# **PRELIMINARY/FINAL DRAINAGE REPORT FOR HIGH PLAINS FILING NO. 1**

PCD FILE NO's: SP-18-003  
SF-18-024

PRELIMINARY/FINAL DRAINAGE REPORT  
HIGH PLAINS FILING NO. 1

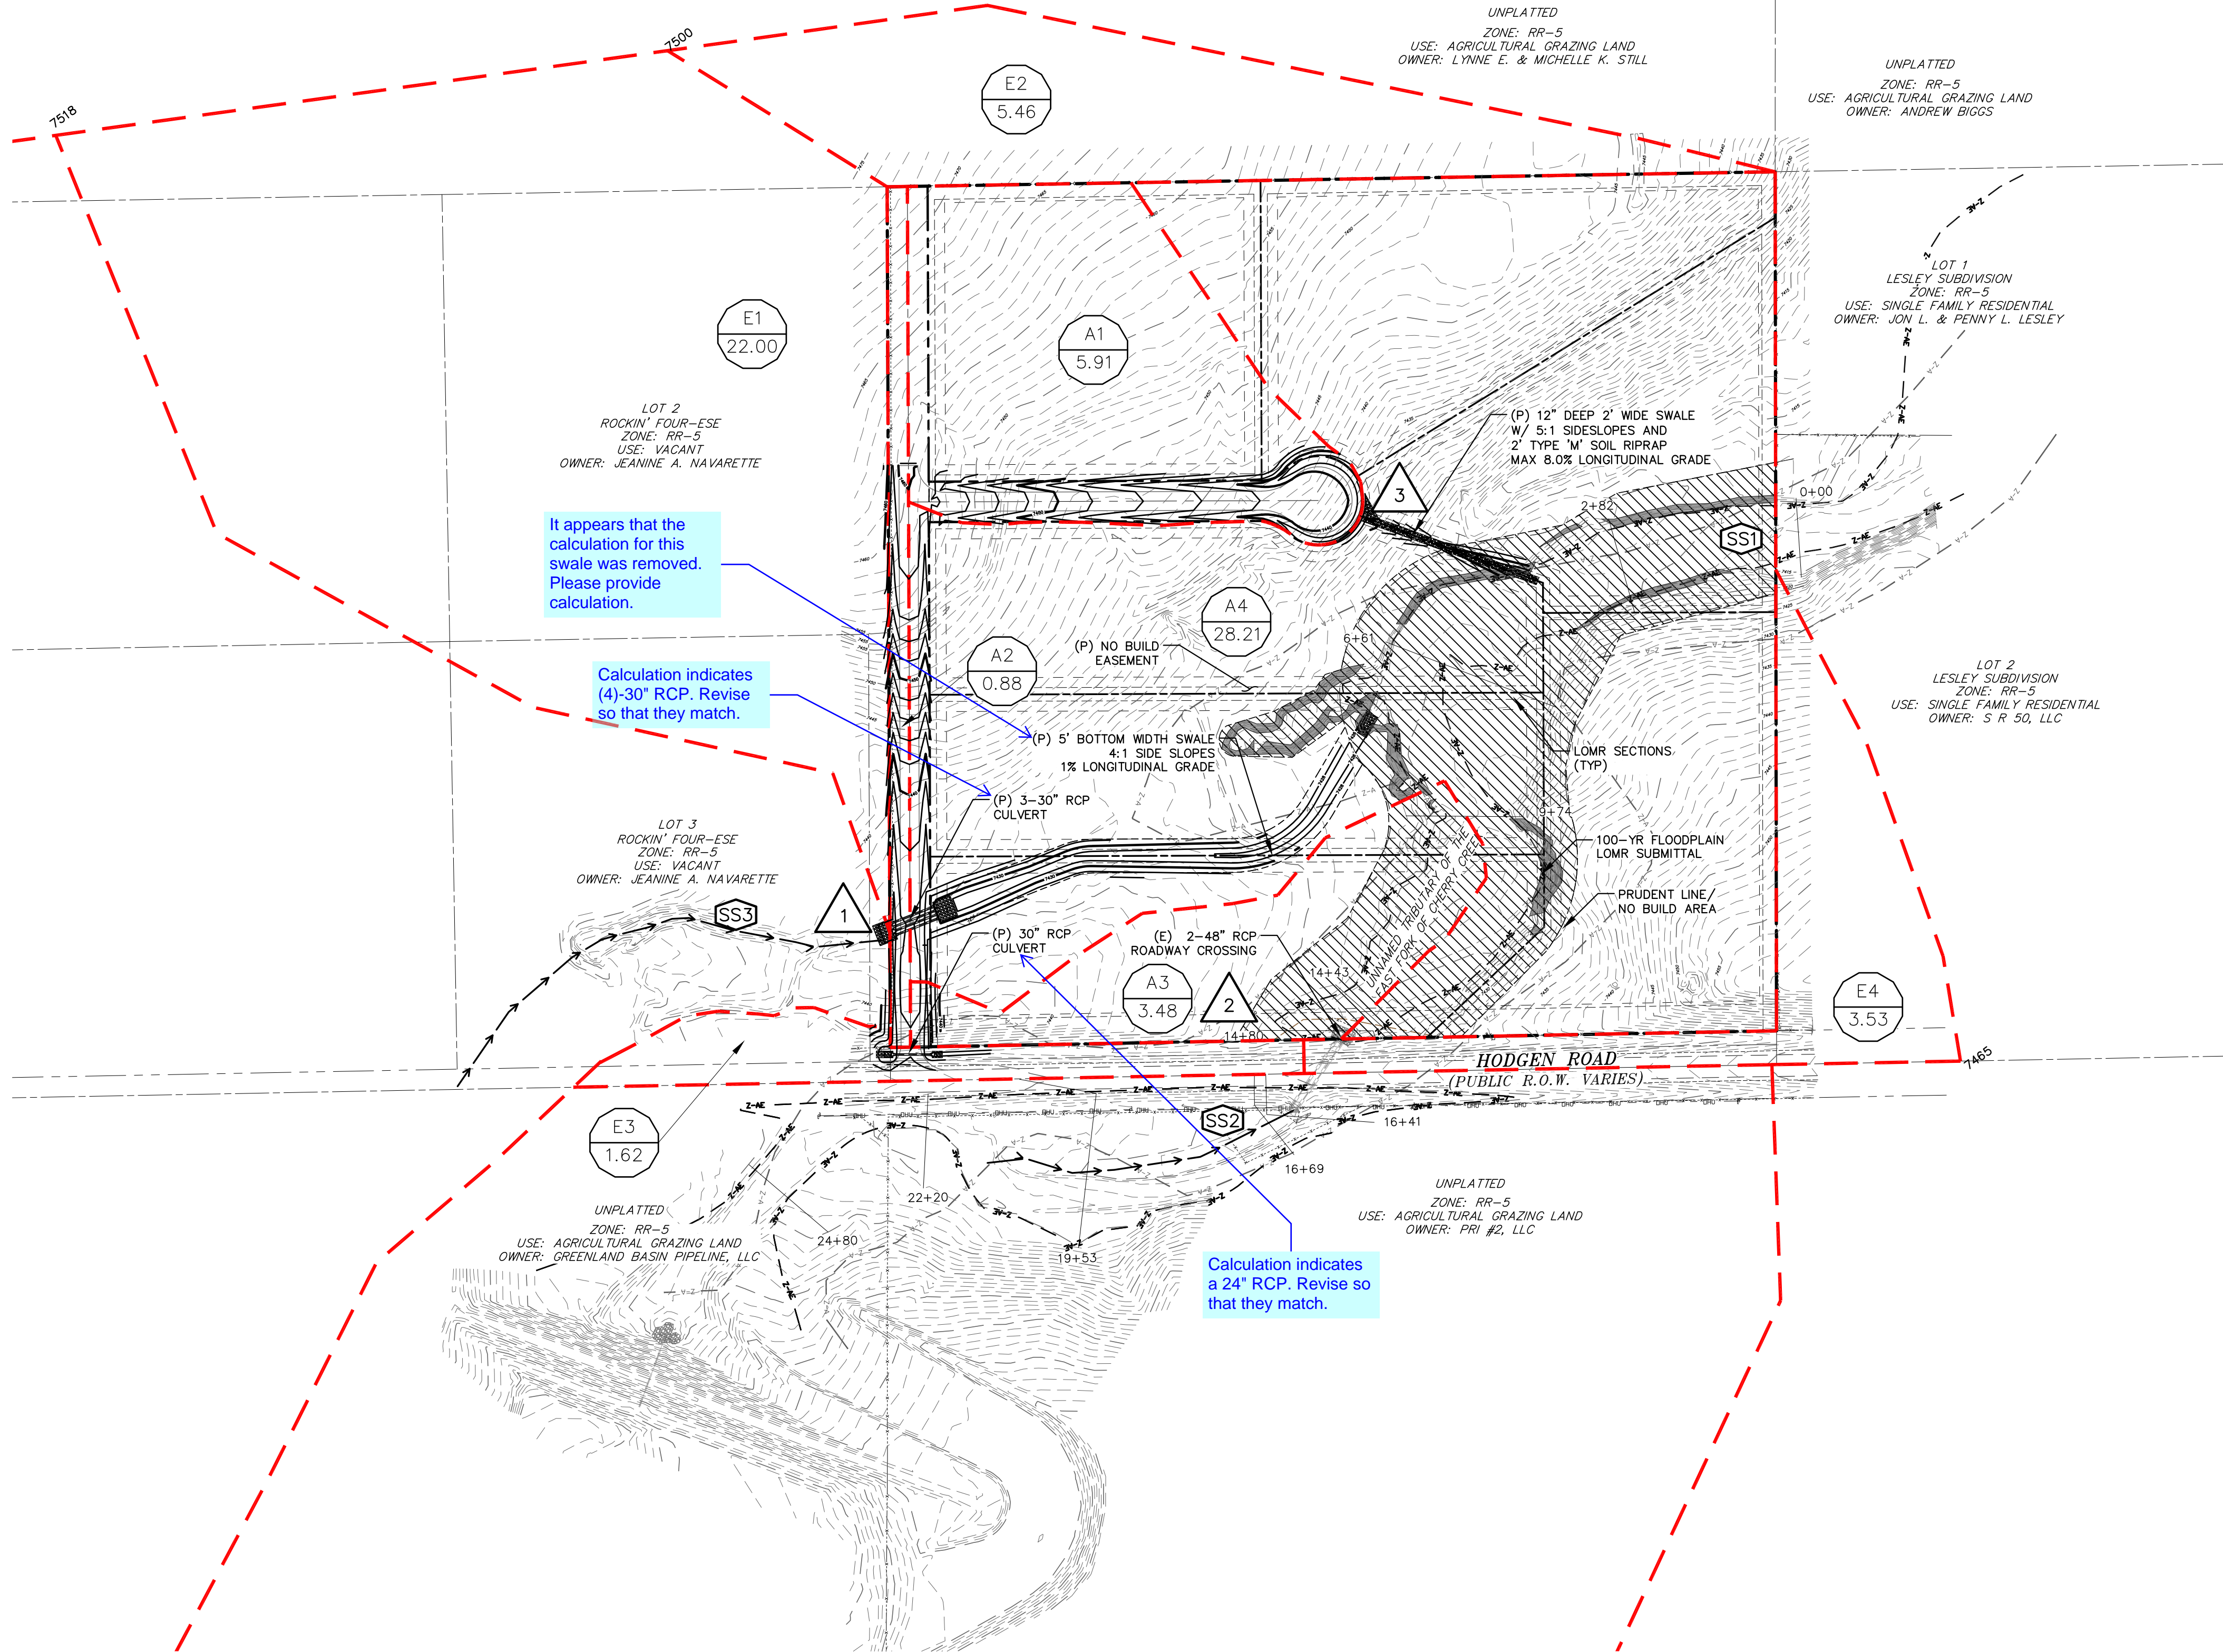
It appears that the calculation for this swale was removed. Please provide calculation.

Calculation indicates (4)-30" RCP. Revise so that they match.

Calculation indicates a 24" RCP. Revise so that they match.
